Access Compliance Report

Public Rights-of-Way

Intersection ID: 47611	Main Street: WYALONG_DR	Cross Street: MINTWORTH_AV	Location: NW
ADA ID: B51DCA21AEB9	Ramp Type: Perp	Initial Pass/Fail: Fail	Overall Compliance: No
Severity Score: 13.75			
Codes/Mitigation Info/Possible Solution		Field Measurements/Component Compliance

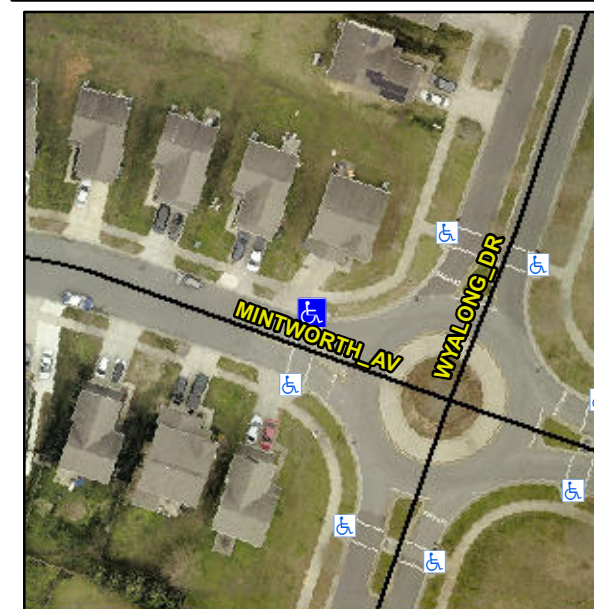
Not Found, R304.2.2, R304.5.3

Compliance	Description	Data	Compliance	Description	Data
N/A	Ramp Length (in)	83.0	No	Ramp Slope (%)	8.6
Yes	Ramp Width (in)	75.0	No	Ramp XSlope (%)	2.5
N/A	Flare Type LT	N/A	N/A	Flare Type RT	N/A
N/A	Flare Slope LT (%)	N/A	N/A	Flare Slope RT (%)	N/A
N/A	Flare Traversable LT?	N/A	N/A	Flare Traversable RT?	N/A
N/A	Landing Length (in)	N/A	N/A	DWS Provided?	N/A
N/A	Landing Width (in)	N/A	N/A	DWS Contrast?	N/A
N/A	Landing Slope (%)	N/A	N/A	DWS Length (in)	N/A
N/A	Landing X Slope (%)	N/A	N/A	DWS Full Width?	N/A
N/A	Landing Curb? (Y/N)	N/A	N/A	DWS Offset (in)	N/A
N/A	Shared Landing?	N/A			
N/A	Gutter Ponding?	N/A	N/A	Gutter Slope (%)	N/A
N/A	Gutter Lip Ht (in)	N/A	N/A	Gutter X Slope (%)	N/A
N/A	Painted X Walk1?	Yes	N/A	Painted X Walk2?	N/A
	X Walk 1 Direction	To SW		X Walk 2 Direction	N/A
N/A	X Walk 1 Width (in)	121.0	N/A	X Walk 2 Width (in)	N/A
	X Walk 1 Slope (%)	5.9		X Walk 2 Slope (%)	N/A
	X Walk 1 X Slope (%)	6.8		X Walk 2 X Slope (%)	N/A

Remove & Replace Entire Ramp.
